### Recall Campaign: 4877-1767, 8.1L Throttle Body

Gas engines 8.1

#### Product Safety Recall

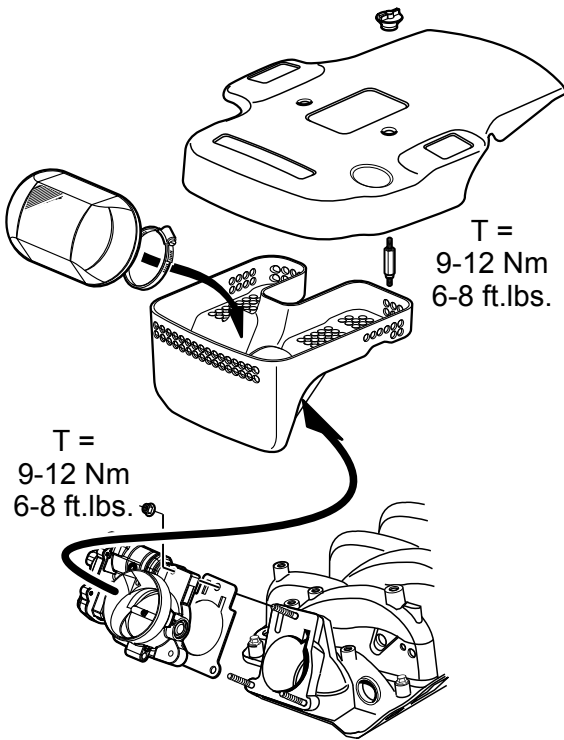
The campaign mark is two white paint dots on the throttle body. See illustration.

Inspect the throttle body for the campaign mark. If present file a warranty claim for the inspection, see below.

If no campaign mark is present the throttle body must be replaced.

Reverse procedure for assembly of new throttle body.  
Place the campaign marks on the new throttle body before installing baffle and cover.
